CITY OF TAUNTON, MA
WASTEWATER TREATMENT FACILITY
SOLIDS HANDLING IMPROVEMENTS
CONTRACT S-2020-3
CWSRF NO. 6690
Addendum No. 4

April 20th, 2021

Item 1: Gravity Thickening Tanks Plans & Sections

Item 2: Solids Handling Building - Second Floor Plan

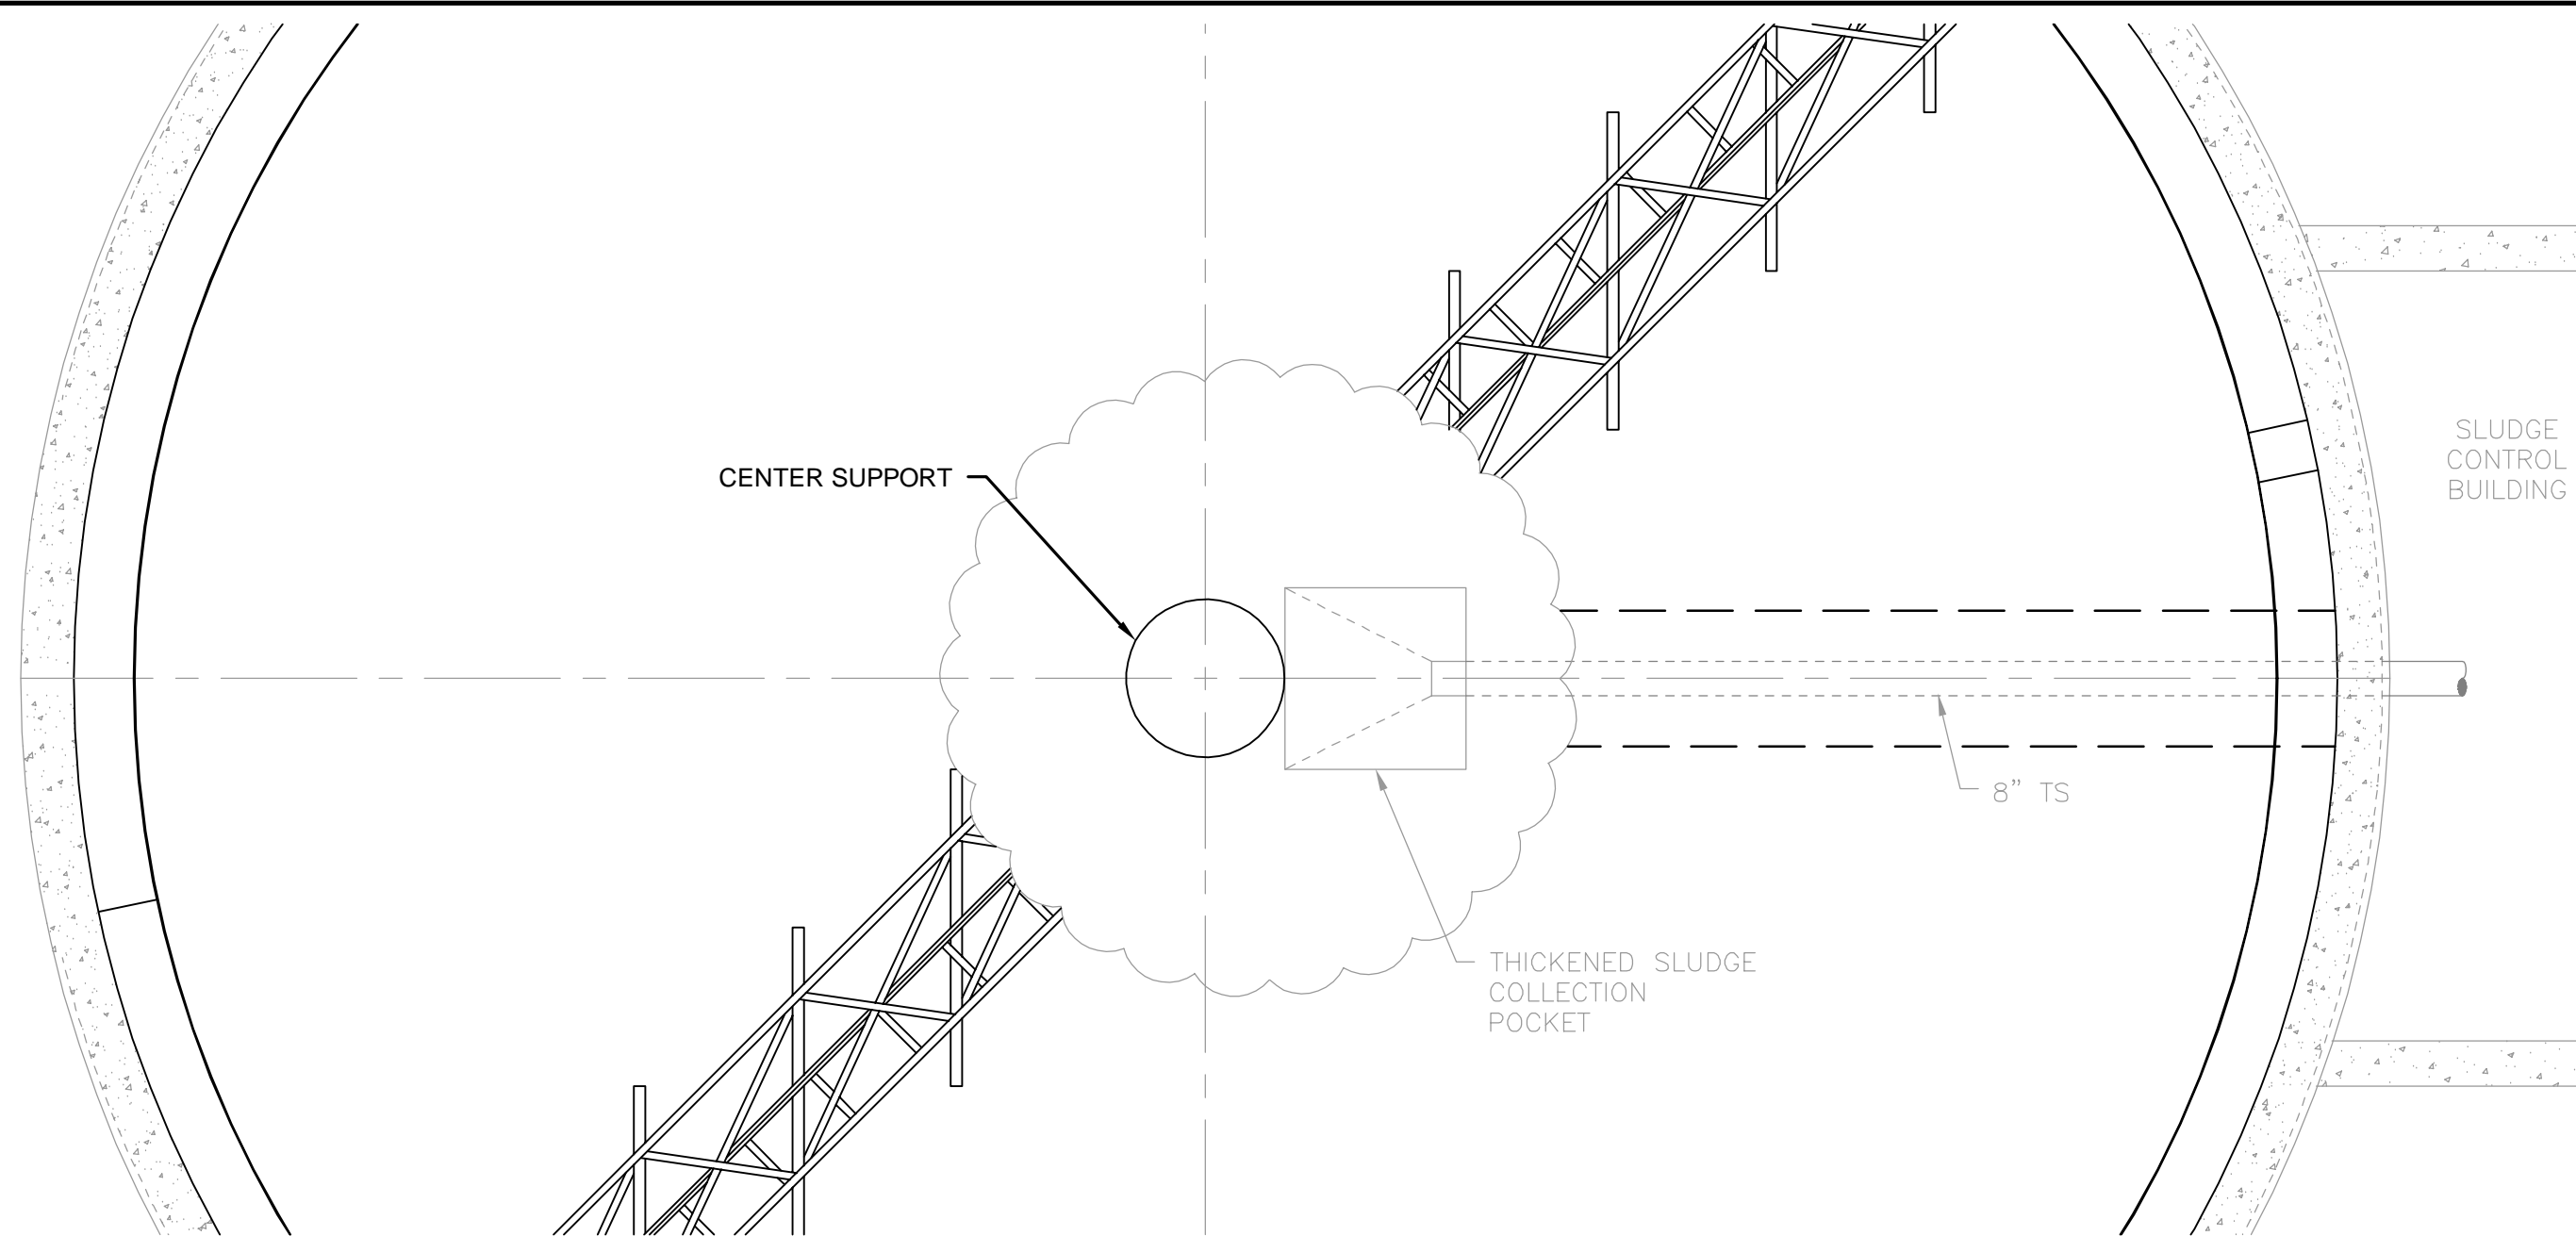
4. PSH-7201 and PSH-7202 on the lower level of E-7.4—these instruments are not shown in the instrument spec table, nor on process drawings.

Response: *PSH-7201 and PSH-7202 are pressure switches for high pressure shutoff of the thickened sludge pumps. These should be provided by the I&C integrator.*
